**Planning Board Meeting Agenda
Brunswick Town Hall
85 Union Street – Council Chambers
Tuesday, February 10, 2026 @ 6:00 PM**

4. **Case No. 25-059 – MaineHealth Mid Coast Cancer Center Renovation:** The Planning Board will review and act upon a **Site Plan Amendment** application submitted by Pine Tree Engineering on behalf of the property owner, Mid

DRAFT FINDINGS OF FACT SKETCH PLAN MAJOR DEVELOPMENT REVIEW PLANNING BOARD

A4.01
ELEVATIONS-
EXTERIOR- BUILDING

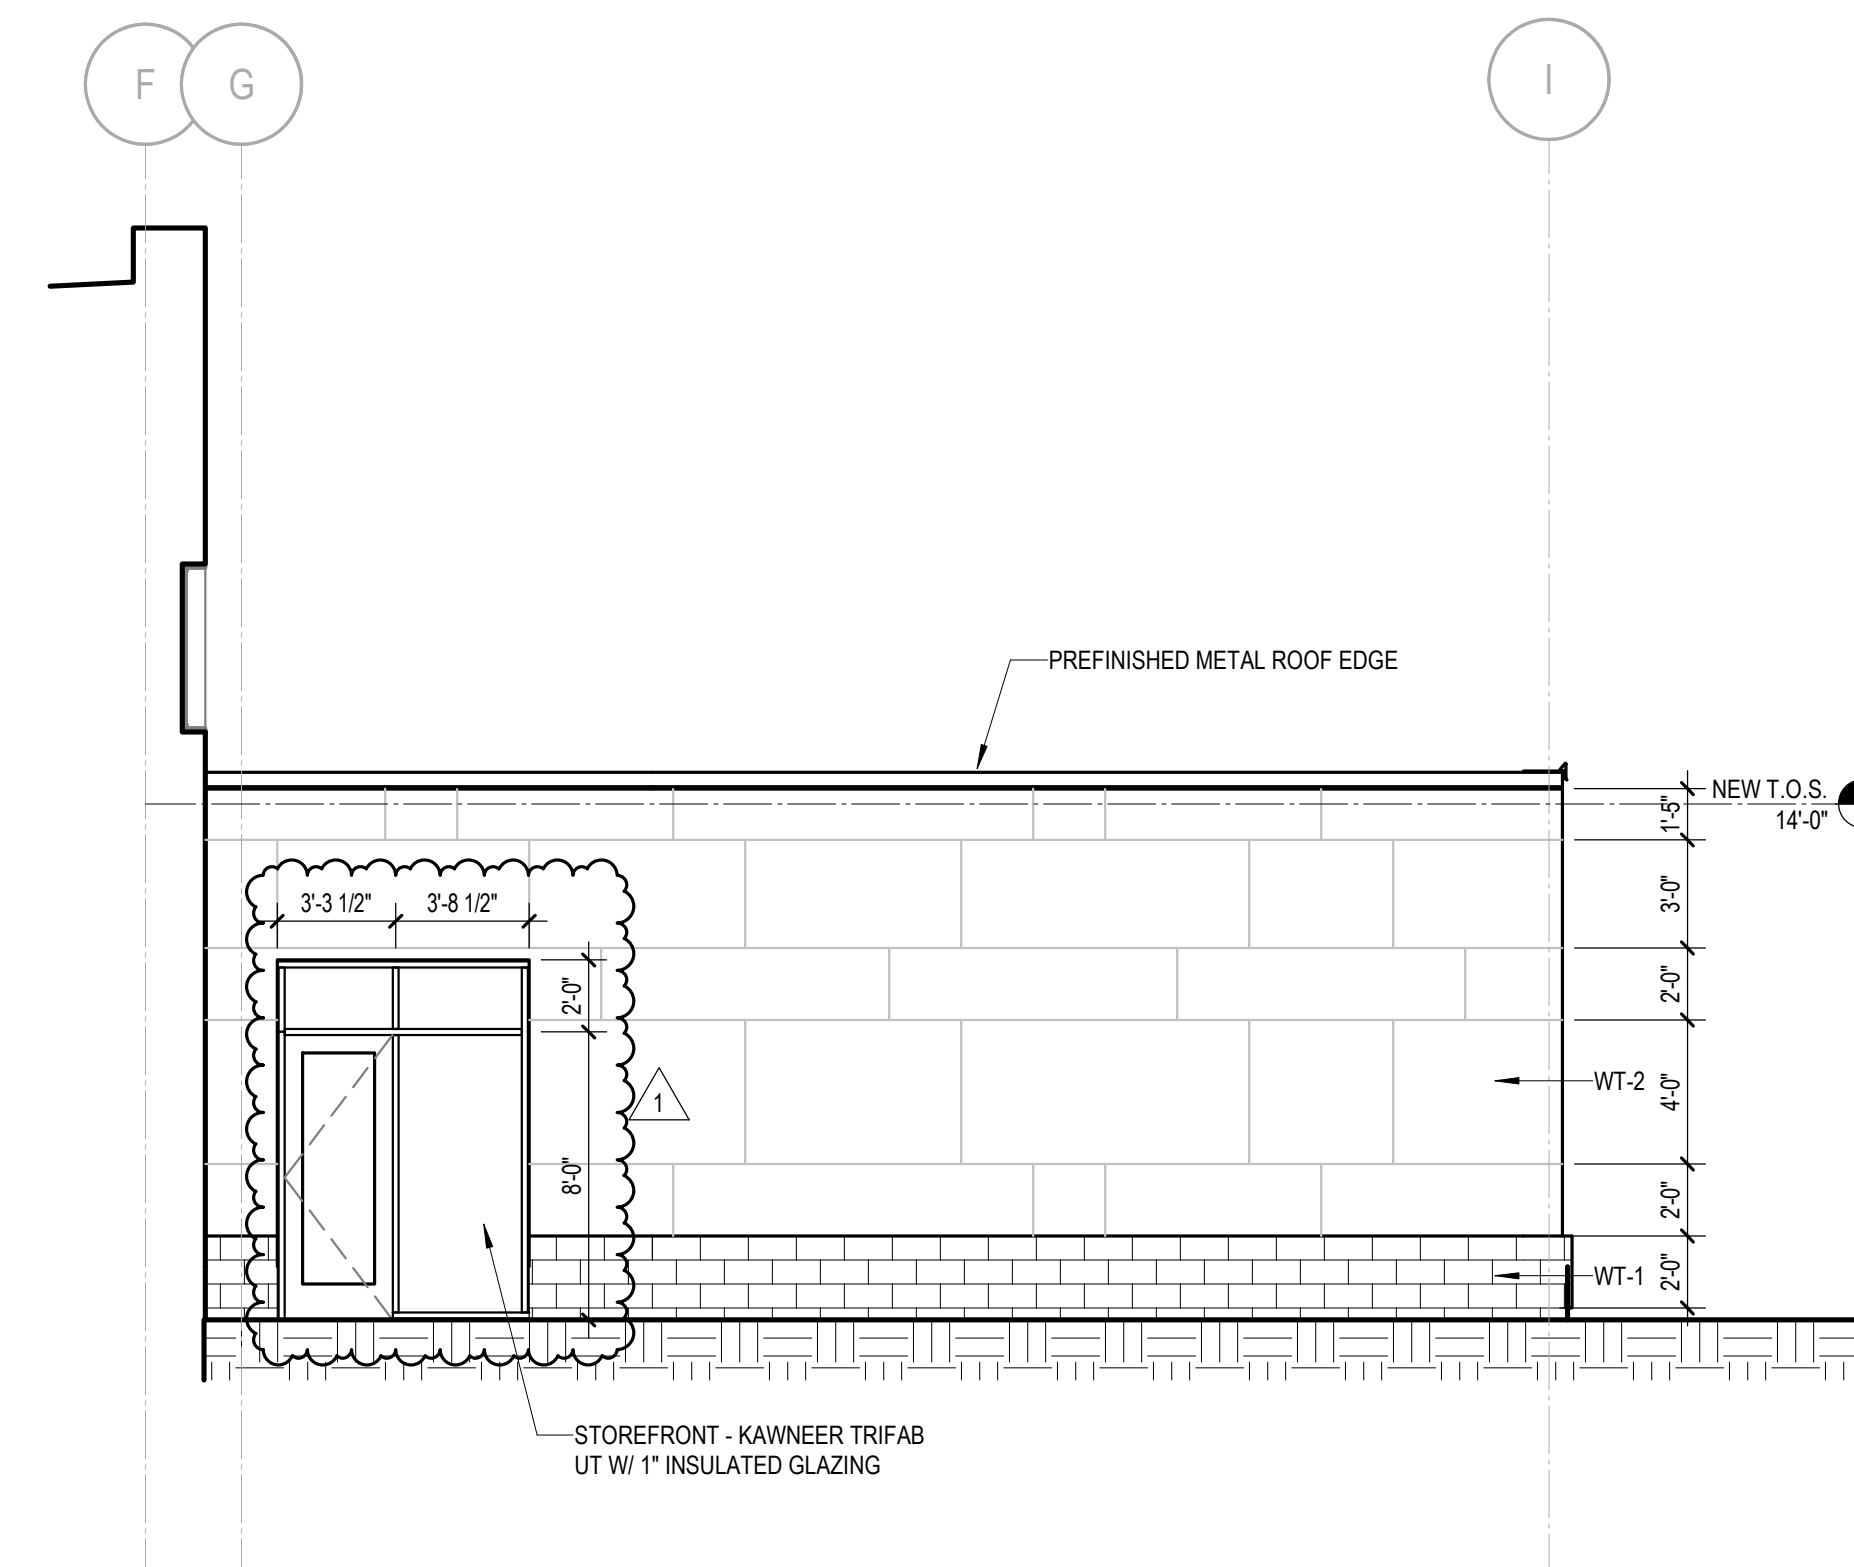
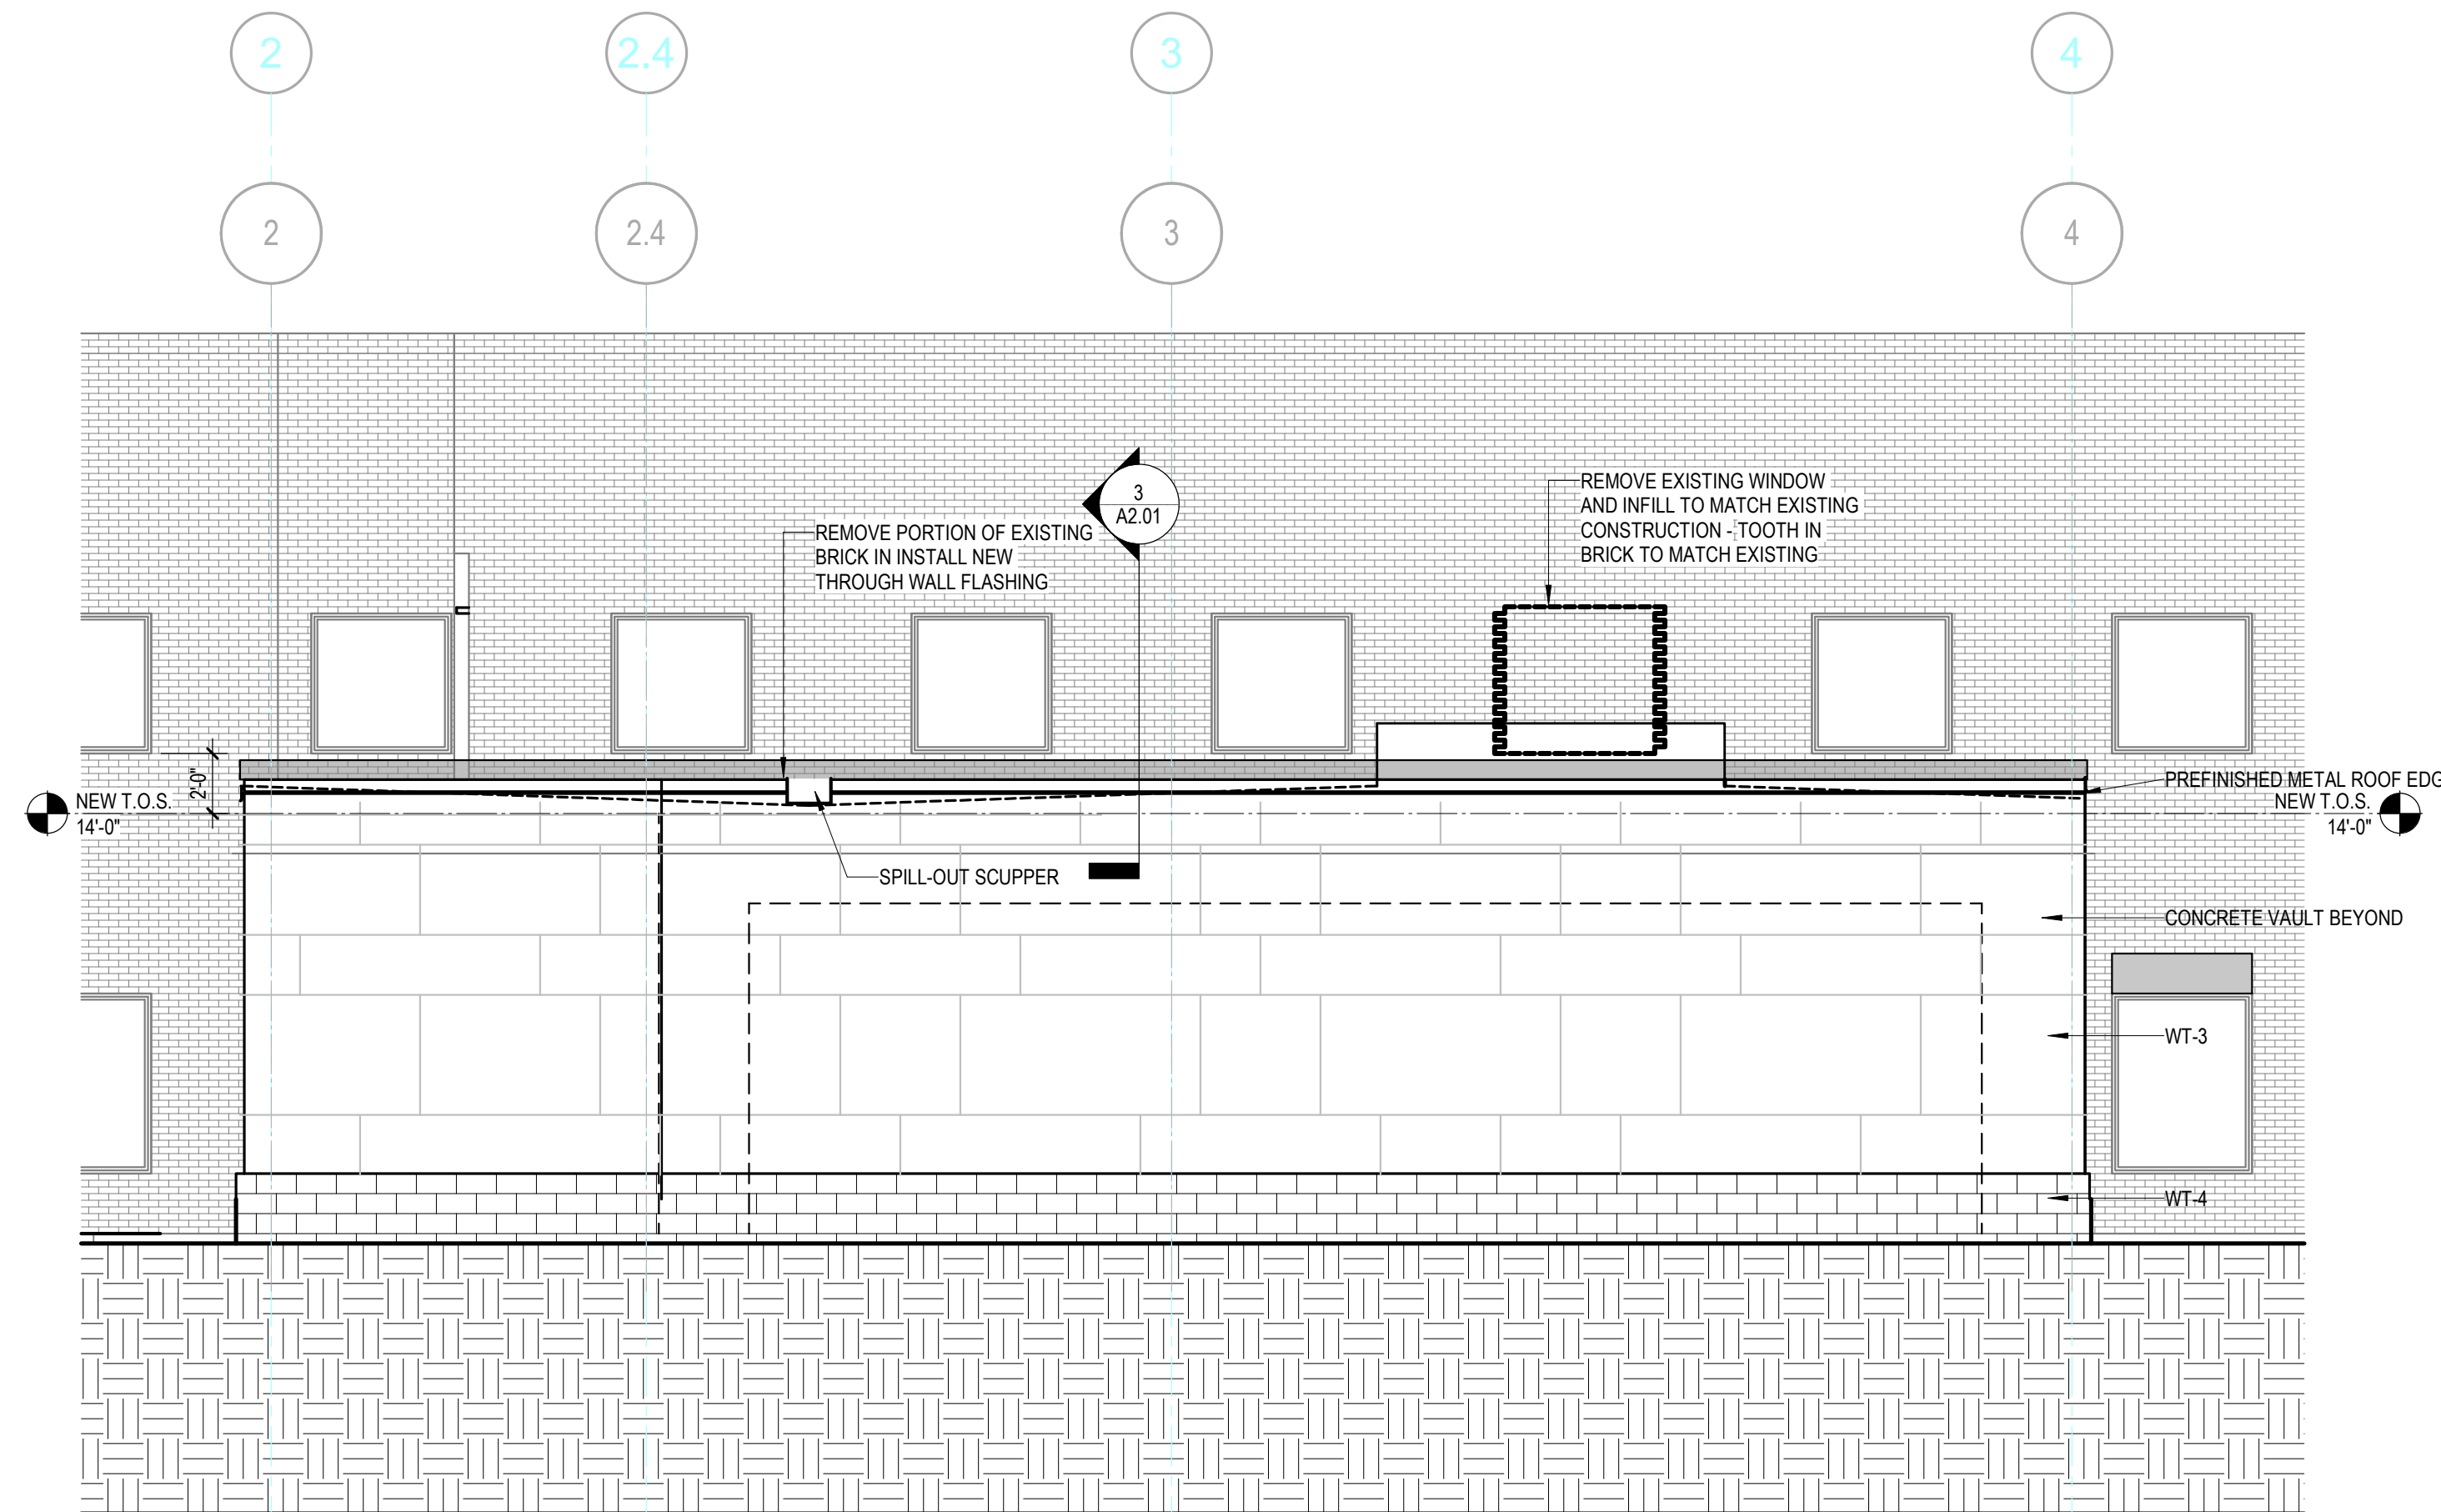
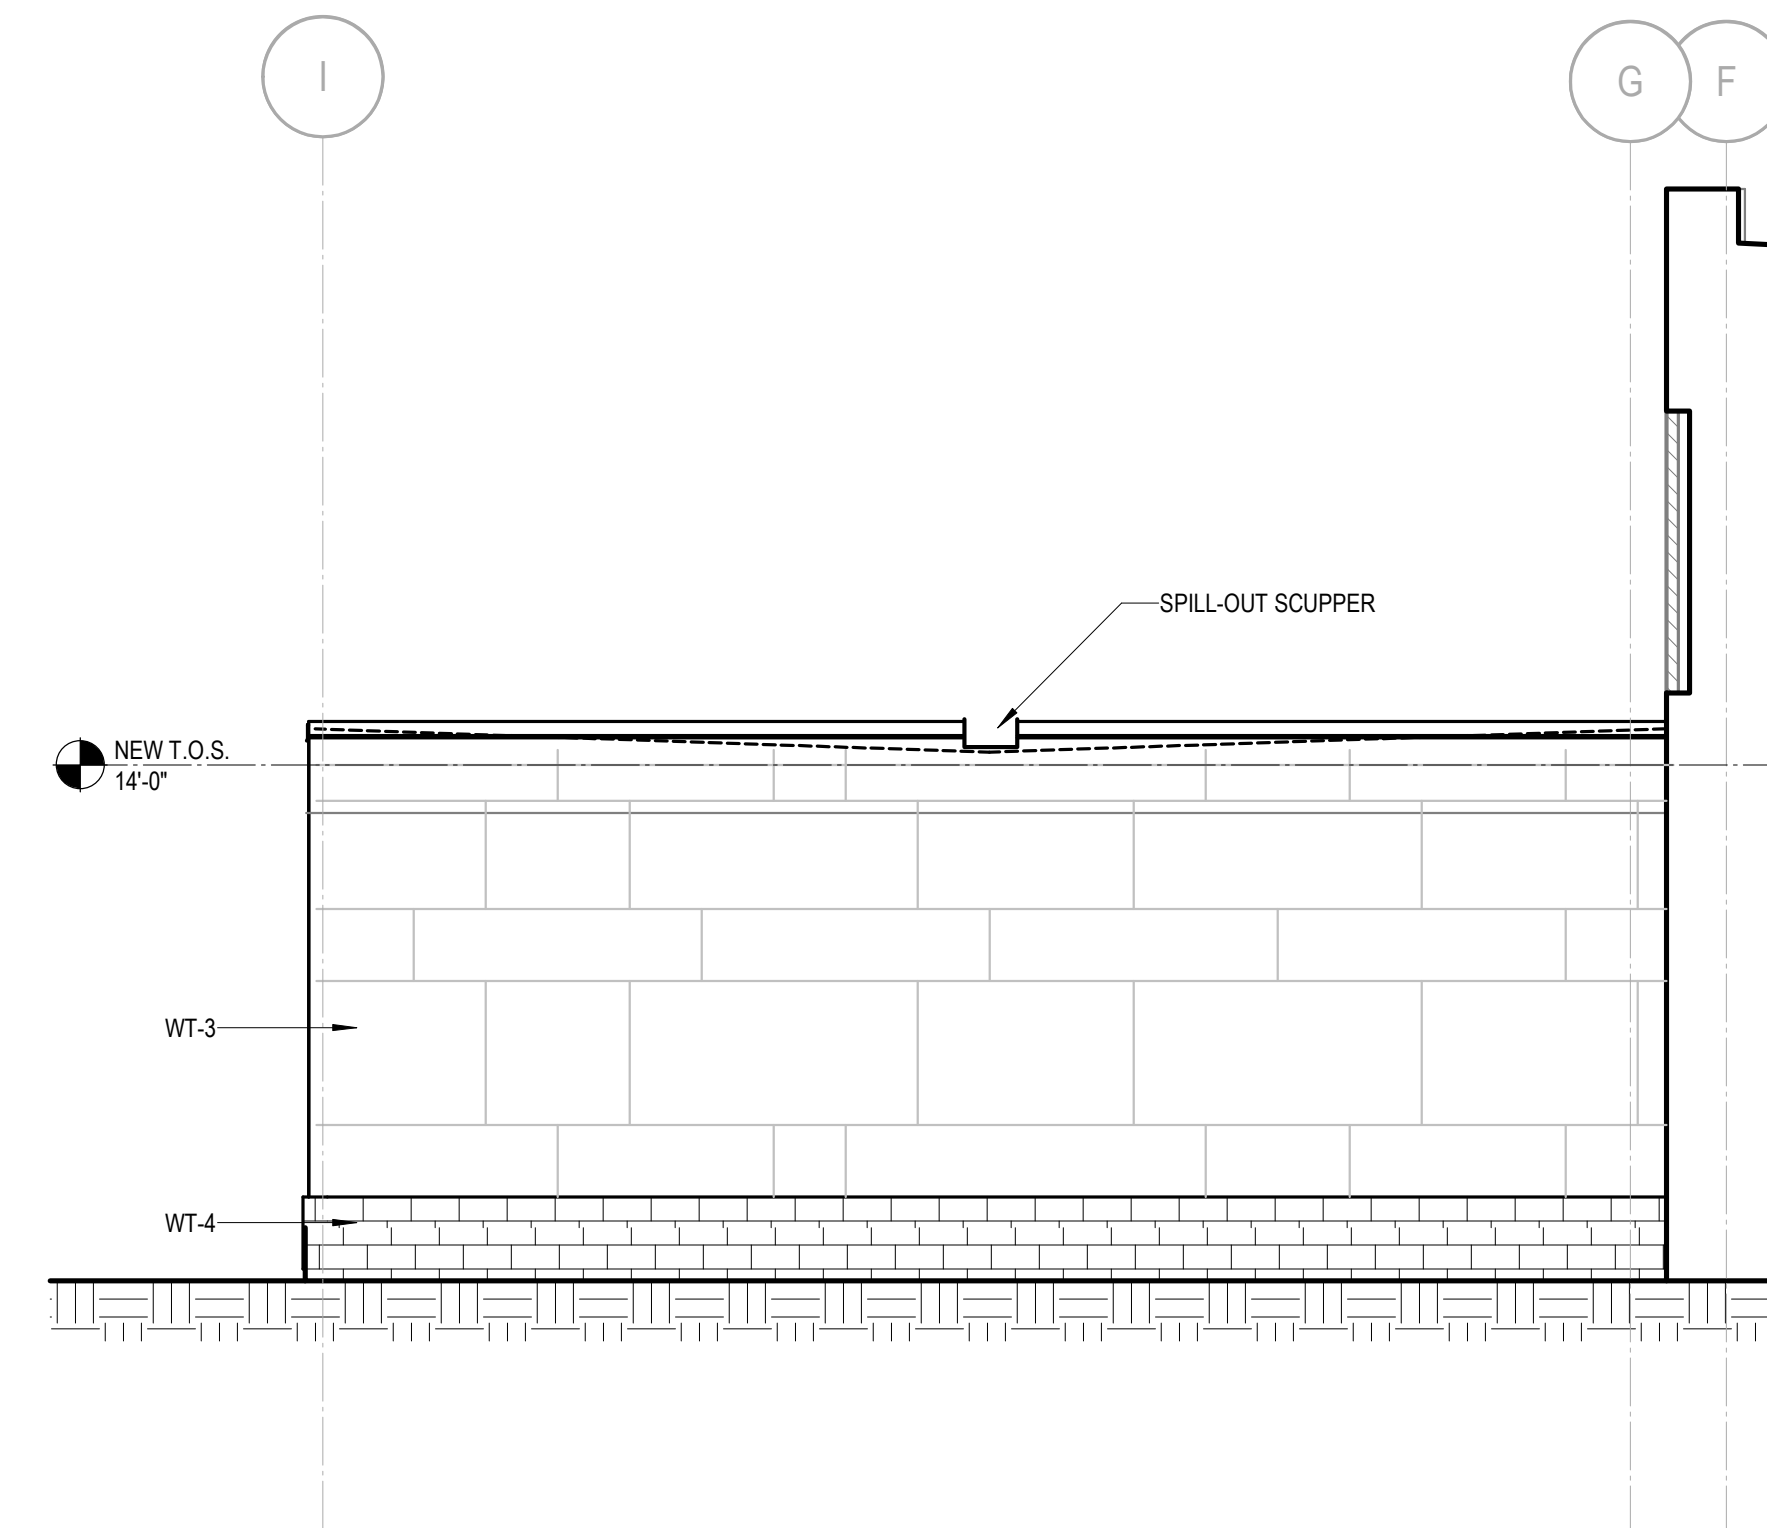
3. Add ornamental grass along parking lot side of pharmacy, near bollards	See Section B-B on AS3.00 Civil Details
Architecture Comments	
4. Review Cooks Corner Design Standards, specifically Section 3.4 Façade Requirements, and within 3.4.j.	See Exhibit 8: Cook's Corner Design Standards Narrative.
Engineering Comments

The two additions to 81 medical center drive are secondary facades according to the definition in Section 3.4 Façade Requirements item C.
